DESIGN CHANGES

Project Name **County Flats, Sandfields**
Project Ref **OAD_5174**
Drawing Ref **1211**
Drawing Name **Flat Type Col.1**
Drawn By **WS**

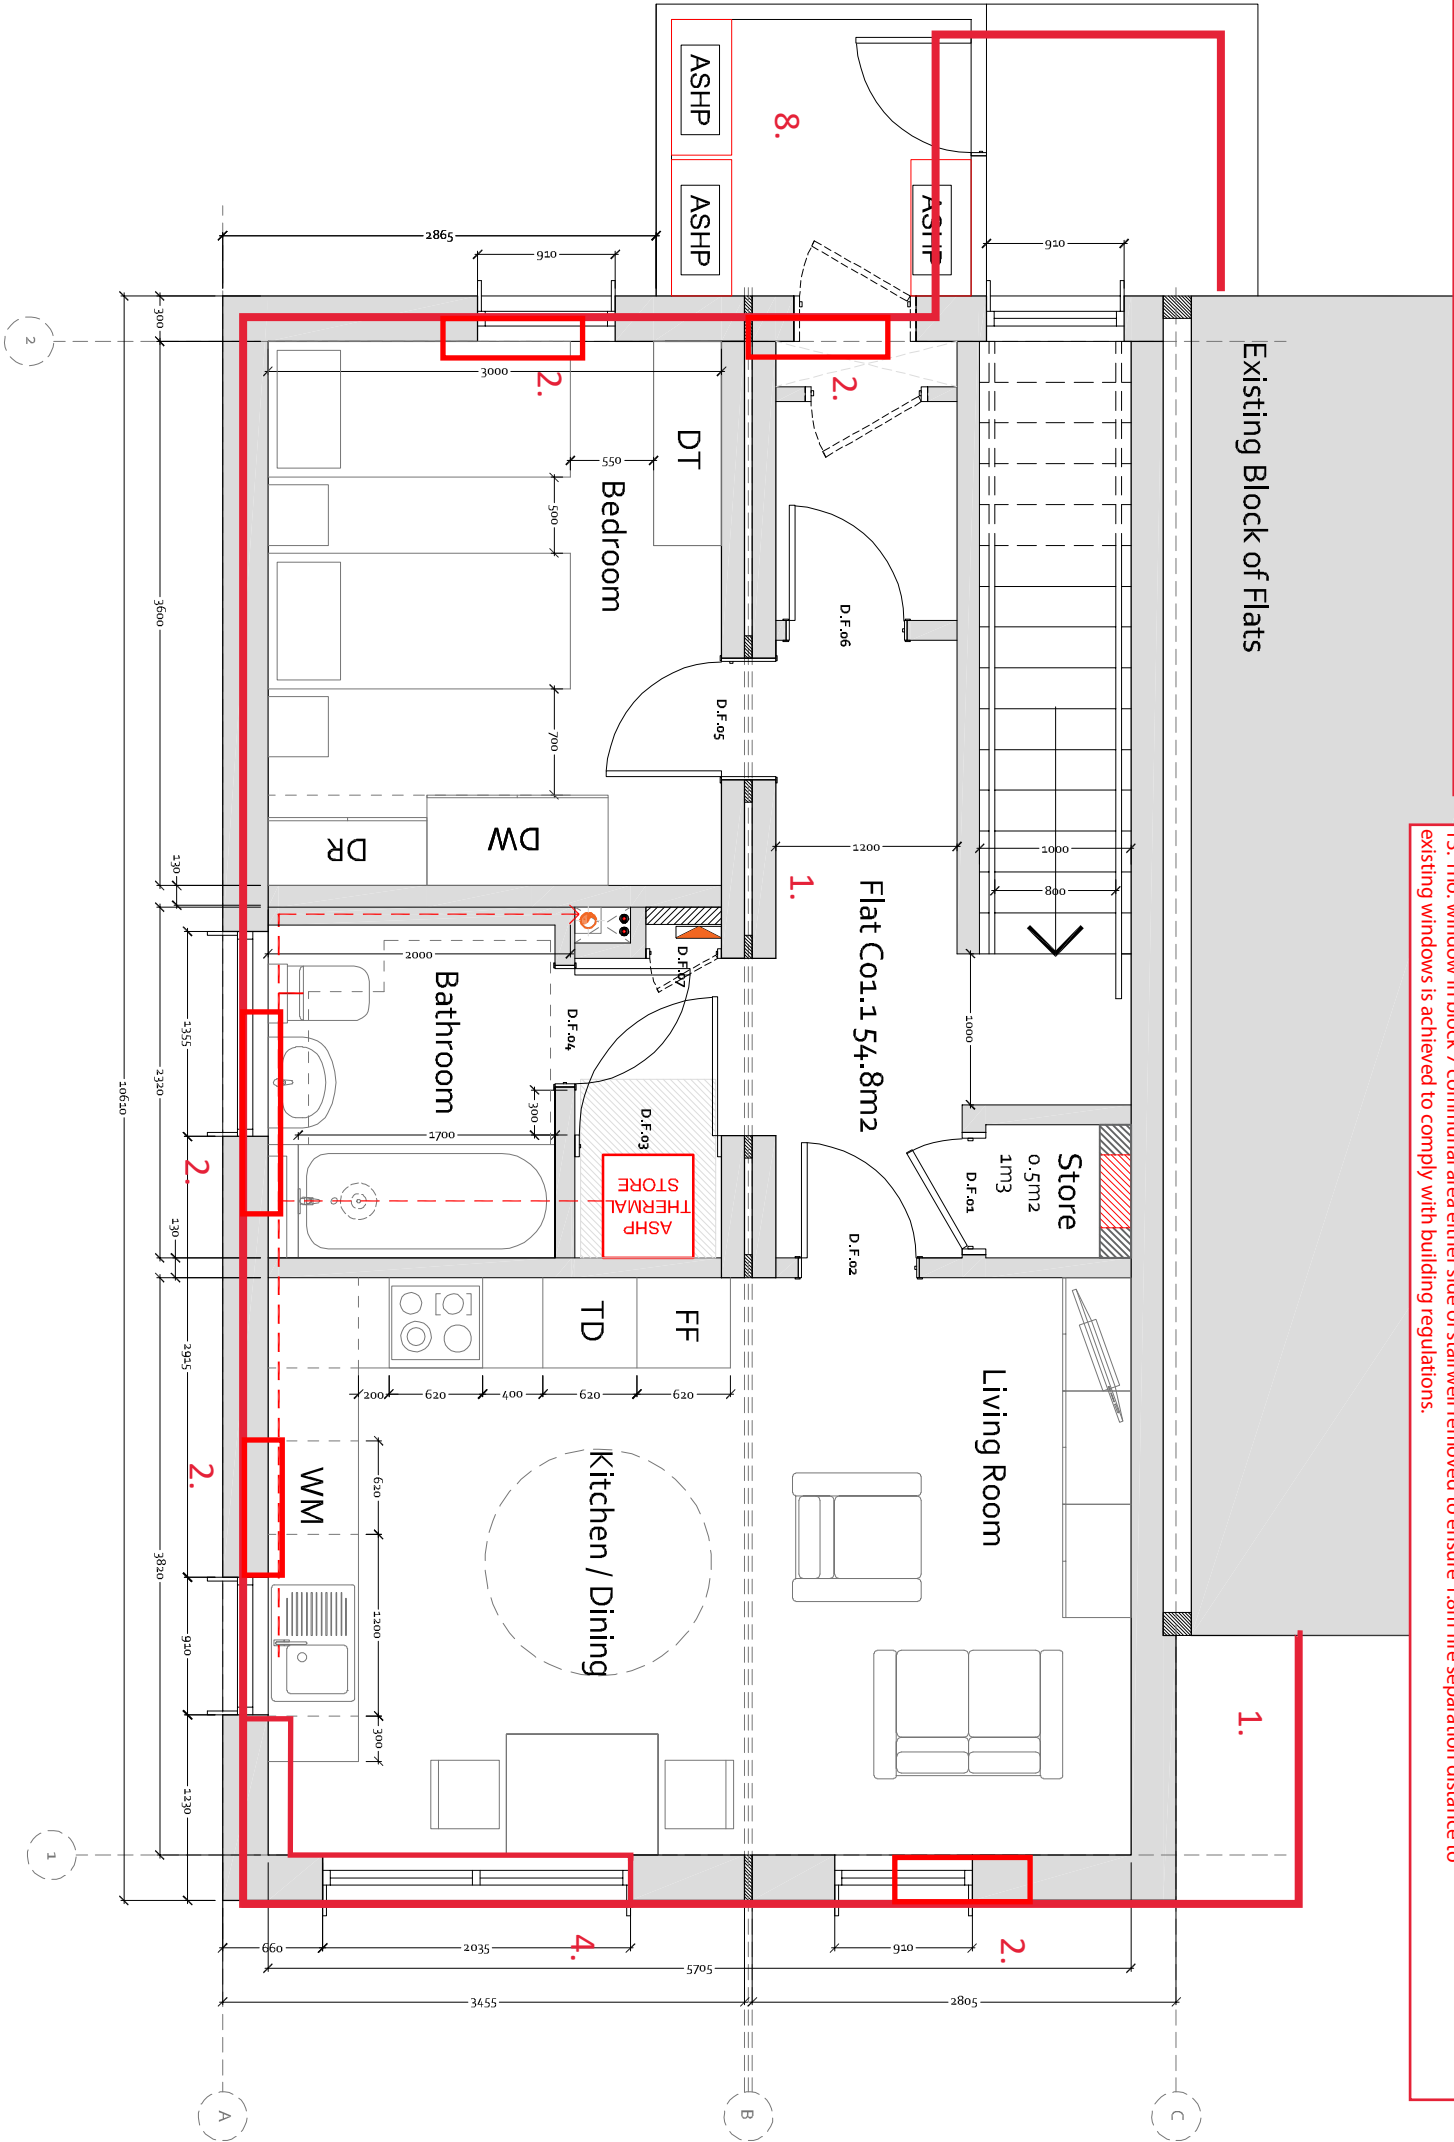
1. Modular end links re-positioned slightly off existing buildings, with the party wall straightened and porch projections aligned with this wall, to ensure modular construction can be achieved off site.
2. Windows have been slightly re-positioned to the new build to suit the structural design of the modular units and the constraints of the timber frame.
3. Parapet to modular end blocks have been lowered by approx 900mm to comply with the structural wind loadings and timber frame design.
4. Corner windows have been removed and replaced with 2no. Windows on either corner, again due to the structural and timber frame design of the blocks.
5. PV panels have been omitted from the end modular units to suit the structural and timber frame design of the blocks.

6. Ground floor Juliet balcony added to existing flats to provide better security whilst ensuring the open areas remain as communal spaces.
7. Air source heat pump external louvre enclosure amended to be single storey over entrance canopy to end link blocks.

8. External air source lowered enclosure handed to provide internal riser/access requirements for maintenance.
9. Buggy/cycle store added to block 6 and 7 parking courtyards.

10. Bin stores slightly re-positioned to suit existing drainage runs, with bin store near block 6 amended in size to suit located of bedroom window.
11. Footpaths amended to be Tarmac.

12. Windows in communal area to the linked blocks made narrower to ensure 1.8m fire separation distance to existing windows is achieved to comply with building regulations.

13. 1no. window in block 7 communal area either side of stairwell removed to ensure 1.8m fire separation distance to existing windows is achieved to comply with building regulations.

ASHP location moved to allow uninterrupted distribution to all flats.
Window position moved to stairway.
